**SUBJECT: NEW VEHICLE RECOMMENDED DEMONSTRATION / DELIVERY HOLD
Customer Satisfaction Program 24B41**

Certain 2024 Model Year F-150 Vehicles Equipped With A 2.7L Engine - Powertrain Control Module (PCM) Reprogram and Air Conditioning Compressor Inspection

Customer Satisfaction Program 24B41

FIGURE 1

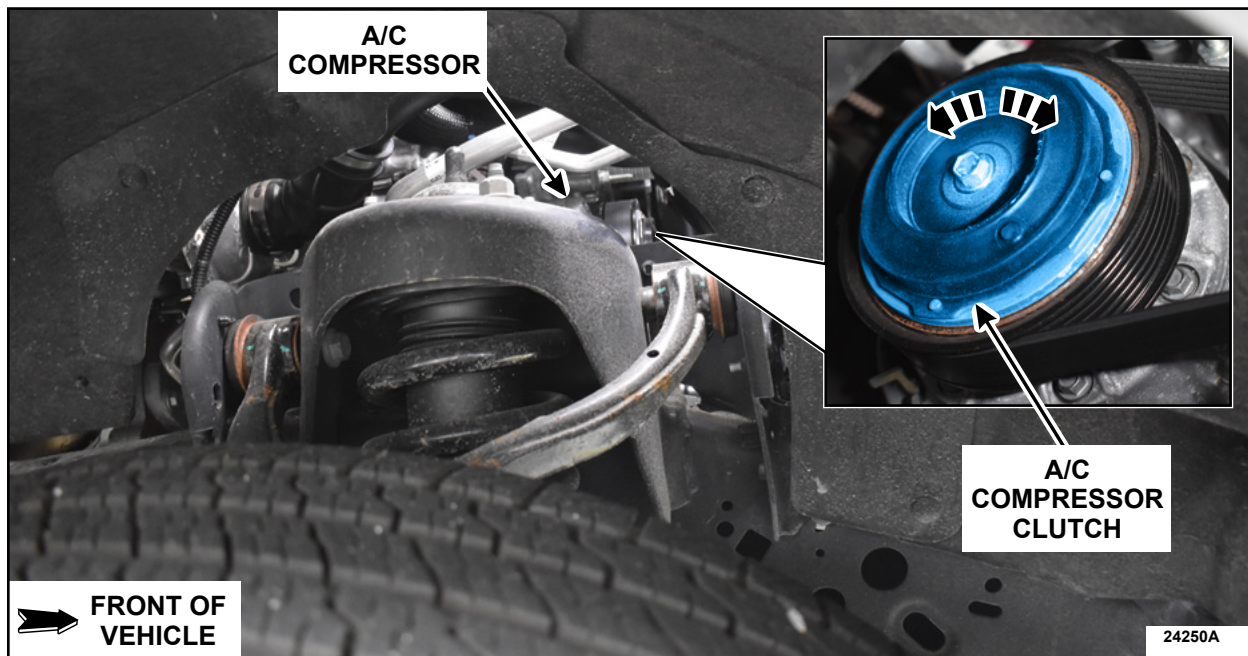
2. With the engine off, through the Right Hand (RH) wheel well, rotate the A/C compressor clutch by hand at least one revolution each direction. See Figure 1 and video link below.

- Does the A/C compressor clutch rotate freely?

YES - Proceed to Powertrain Control Module (PCM) Programming on Page 7. Once the PCM programming is complete, diagnose the cabin A/C issue outside of this recall. This completes the FSA.

NO - Proceed to Step 3.
